**Economic Commission for Europe****Inland Transport Committee****World Forum for Harmonization of Vehicle Regulations****Working Party on Lighting and Light-Signalling****Eighty-First session**

**Regulations Nos. 37 (Filament lamps), 99 (Gas discharge light sources), 128 (Light emitting diodes light sources) and the Consolidated Resolution on the common specification of light source categories.****Proposal for amendment [7] to the Consolidated Resolution on the common specification of light source categories (R.E.5)****Submitted by the expert from the International Automotive Lighting and Light Signalling Expert Group (GTB)\***

The text reproduced below was prepared by the expert from GTB to introduce new LED substitute light source categories W5W/LEDK and WY5W/LED in the Consolidated Resolution on the common specification of light source categories (R.E.5) (ECE/TRANS/WP.29/1127). The modifications to the existing text of the Resolution are marked in bold for new or strikethrough for deleted characters. This proposal is supported by informal document GRE-81-04.

Figure 1

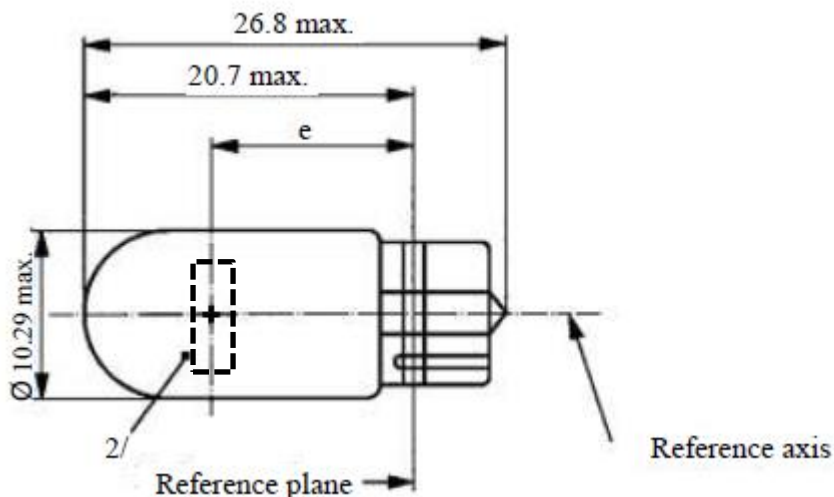
After sheet R5W/LED/1 to 4, insert new sheets W5W/LED/1 to 4, to read:

The drawings are intended only to illustrate the essential dimensions (in mm) of the LED light source.

Dimensions in mm		LED light sources of normal production		Standard LED light sources	
e <sup>2</sup>		12.7 nom.		12.7 nom.	
Cap WX2.1x9.5d in accordance with IEC Publication 60061 (sheet 7004-91A-1)					
Electrical and photometric characteristics		<sup>4</sup>	<sup>7</sup>	<sup>4</sup>	
Rated values	Volts	12	24	12	
	Watts	2		2	
Test voltage	Volts (DC)	13.5	28.0	13.5	
Objective values W5W/LEDK	Power	Watts	2.0 max.	2.5 max.	2.0 max.
	Electrical current	mA	(at 9-16V DC) 30min. 185max.	(at 16-32V DC) 30min. 185max.	(at 9-16V DC) 30min. 185max.
	Luminous flux <sup>1</sup>	lm	50 ± 20 % <sup>3</sup>		50 ± 10 % <sup>3</sup>
	Luminous flux <sup>1</sup>	lm	(at 9 V DC) 9 min.	(at 16 V DC) 5 min.	(at 9 V DC) 9 min.
Objective values <sup>5</sup> WY5W/LED	Power	Watts	2.0 max.	2.5 max.	2.0 max.
	Electrical current	mA	(at 9-16V DC) 30min. 185max.	(at 16-32V DC) 30min. 185max.	(at 9-16V DC) 30min. 185max.

<sup>1</sup> The light emitted shall be white, without a correlated colour temperature restriction.

<sup>2</sup> To be checked by means of a "box system", sheet W5W/LED/2

<sup>3</sup> The value measured at elevated ambient air temperature of 80°C shall be at least 70% of this value

<sup>4</sup> In case of a failure of any of the light emitting elements (open circuit failure), the LED light source shall either still comply to the requirements concerning luminous flux and luminous intensity distribution or stop emitting light whereby, in the latter case, the electrical current draw, when operated between 12 V and 14 V, shall be less than 10 mA

Figure 2

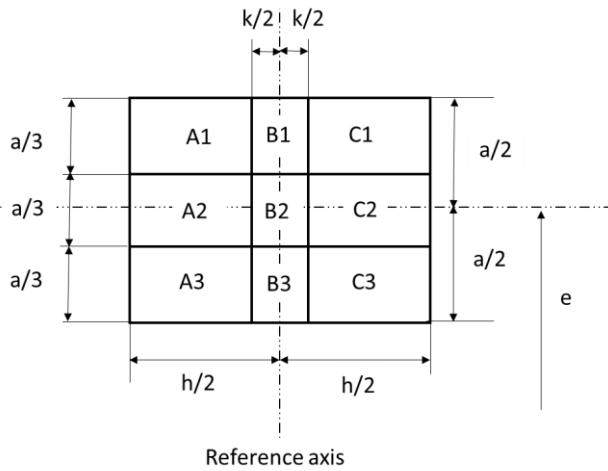
The position of the light emitting area is checked by a box system defined in Figure 2 when operated at test voltage, which shows the projections when viewing along the direction  $\gamma = 0^\circ$  (top view),  $\gamma = \pm 45^\circ$  (inclined view) and  $\gamma = \pm 90^\circ$  (front, rear view) in the plane  $C_0$  (C,  $\gamma$  as defined in Figure 3).

$A=A1+A2+A3$  and  $B=B1+B2+B3$  and  $C=C1+C2+C3$

A, B and C together shall be 70 per cent or more

B shall be 20 per cent or more

A and C shall each be more than 15 per cent

A1, B1 and C1 together shall be less than 50 per cent

A2, B2 and C2 together shall be more than 20 per cent

A3, B3 and C3 together shall be less than 50 per cent

Dimensions in mm	<i>a</i>	<i>h</i>	<i>k</i>
All views (as specified above)	6.0	8.0	1.5

Figure 3

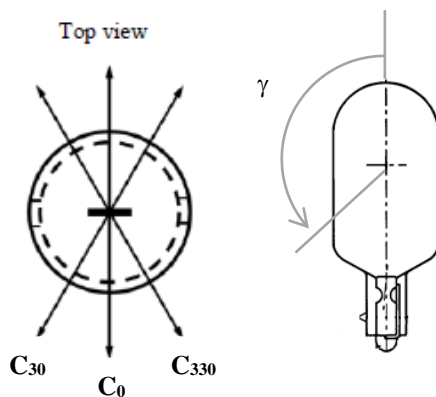
The following test is intended to determine the normalized luminous intensity distribution of the light source in the C-planes as described in Figure 3 when operated at test voltage. The intersection of the reference axis and the reference plane is used as the coordinate system origin.

The light source is mounted on a flat plate with the corresponding holder features. The plate is fixed to the goniometer table by a bracket, so that the reference axis of the light source lines up with one of the rotating axis of the goniometer. The corresponding measurement set-up is described in Figure 3.

The measurements shall be performed in C-planes, which contain the reference axis of the light source. The C-planes to be measured shall be  $C_0$ ,  $C_{30}$  and  $C_{330}$ . The test points for each plane and multiple polar angles  $\gamma$  are specified in Table 3.

The measured luminous intensity values, normalised to the measured luminous flux of the individual light source under test, shall be converted to normalised luminous intensity values of a 1000 lm light source. These data shall comply with the tolerance band as defined in Table 3.

$\gamma$	LED light source of normal production		Standard LED light source	
	Minimum intensity (cd/klm)	Maximum intensity (cd/klm)	Minimum intensity (cd/klm)	Maximum intensity (cd/klm)
-100°	60	140	80	120
-75°	60	140	80	120
-50°	60	140	80	120
-25°	60	140	80	120
0°	60	140	80	120
25°	60	140	80	120
50°	60	140	80	120
75°	60	140	80	120
100°	60	140	80	120

The luminous intensity distribution as described in Table 3 shall be substantially uniform, i.e. in between two adjacent grid points the relative luminous intensity requirement is calculated by linear interpolation using the two adjacent grid points.
